RA20-016

Subject: Corrected drawing for one-line electrical power supply for LaSalle Hardened Containment Vent System (HCVS) Final Integrated Plan (FIP)

Attachments: Drawing 1E-0-4000FA, revision A, *Key Diagram Hardened Containment Vent System (HCVS) 125VDC Distribution Panel 0DC52E*

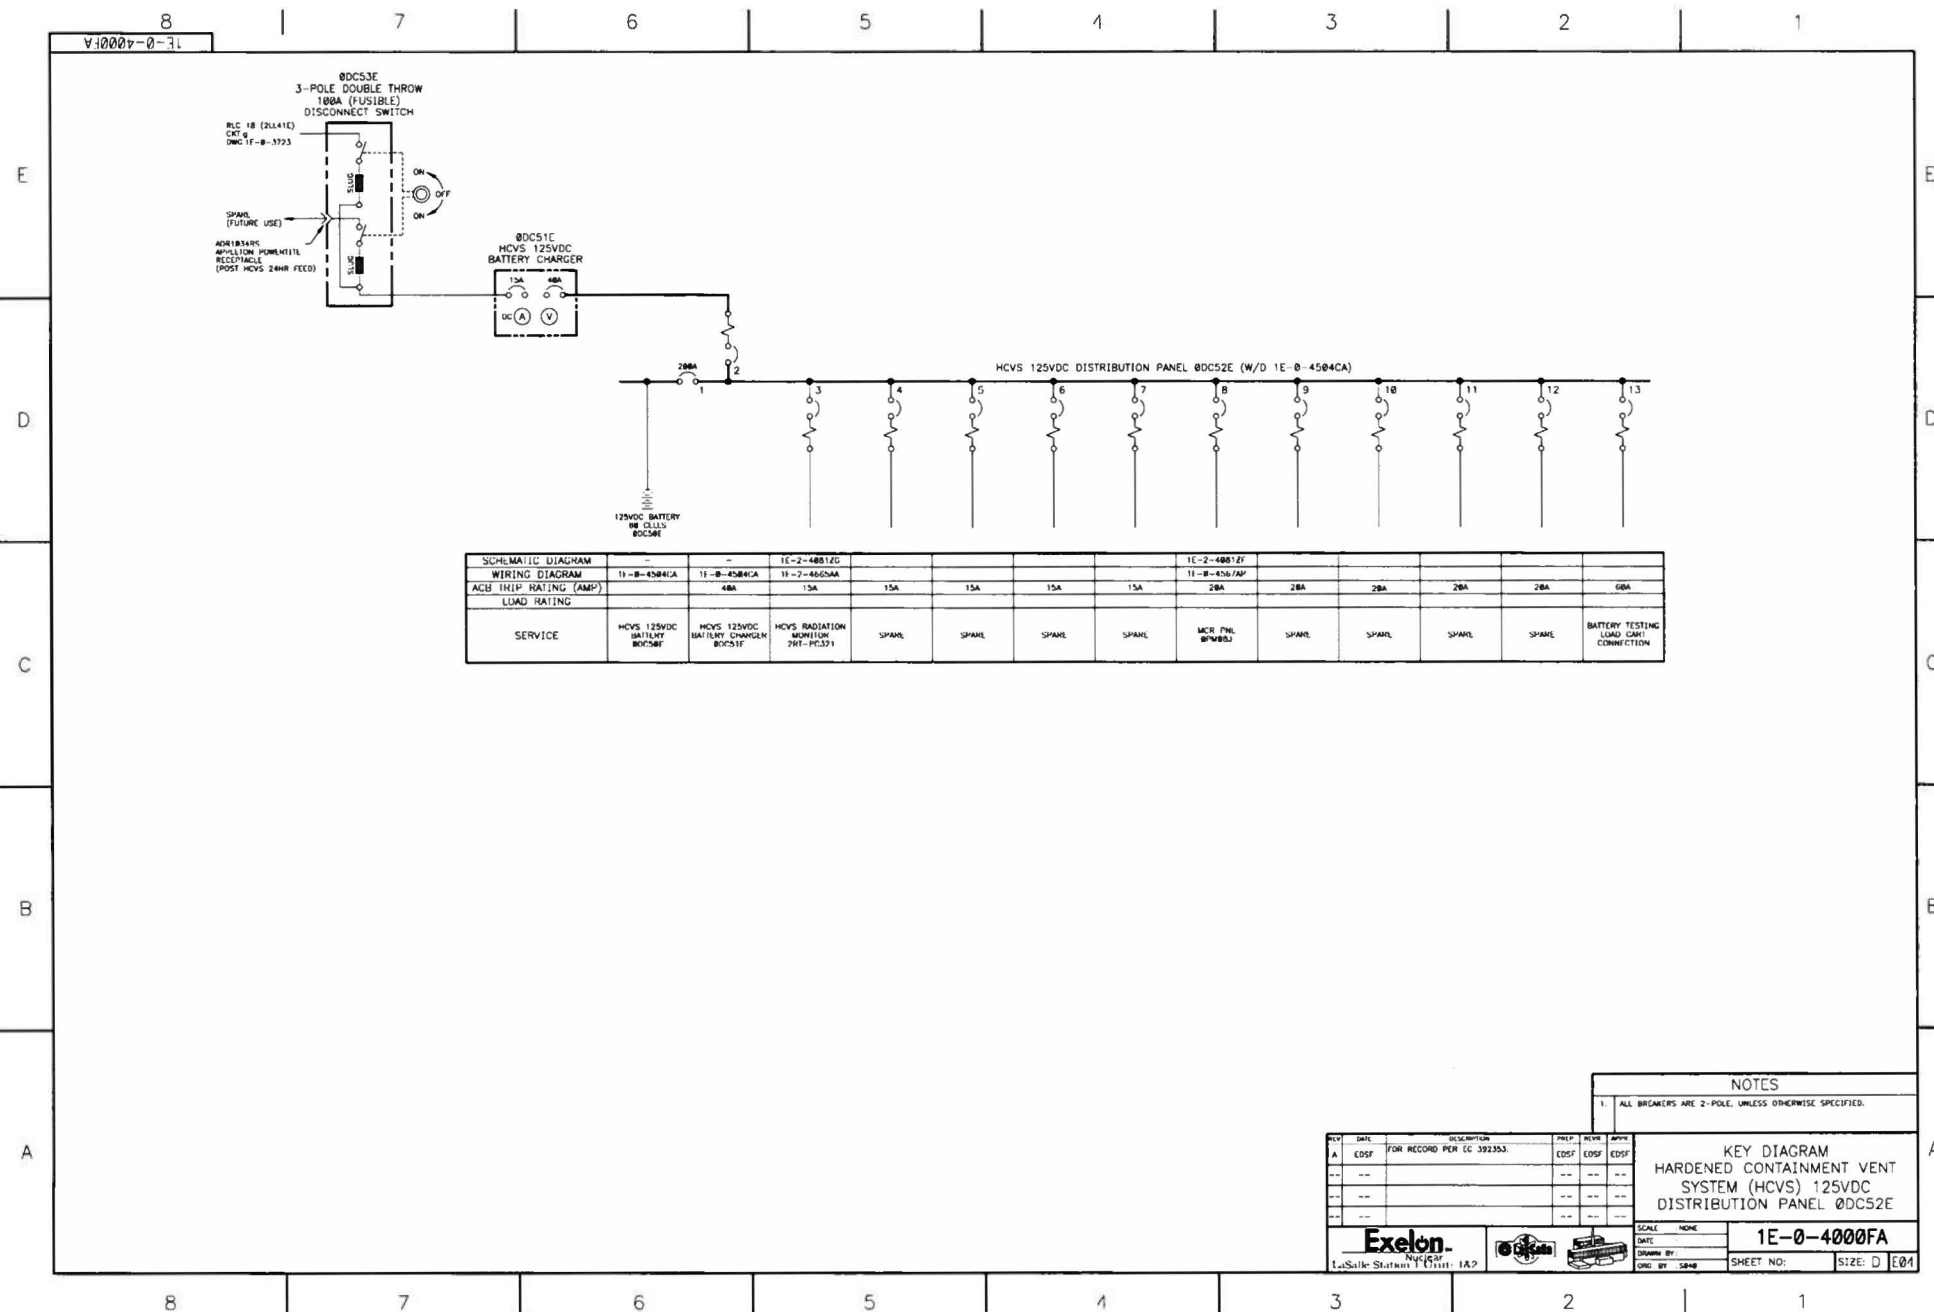
In accordance with 10 CFR 50.9, "Completeness and accuracy of information" LaSalle County Station (LSCS) is providing a corrected drawing for the HCVS FIP report previously communicated to NRC by letter dated December 14, 2018. While reviewing portions of LaSalle Station's FIP for the HCVS, it was discovered that the incorrect diagram was submitted in Attachment 3. The attachment is labeled as the "One Line Diagram of HCVS Electrical Power Supply." The drawing that should have been submitted in that attachment is 1E-0-4000FA, enclosed with this letter.

While reviewing portions of LaSalle Station's Final Integrated Plan (FIP) for the hardened containment vent system (HCVS), it was discovered that the incorrect diagram was submitted in Attachment 3. The attachment is labeled as the one-line diagram of HCVS electrical power supply. The drawing that should have been submitted in that attachment is 1E-0-4000FA.
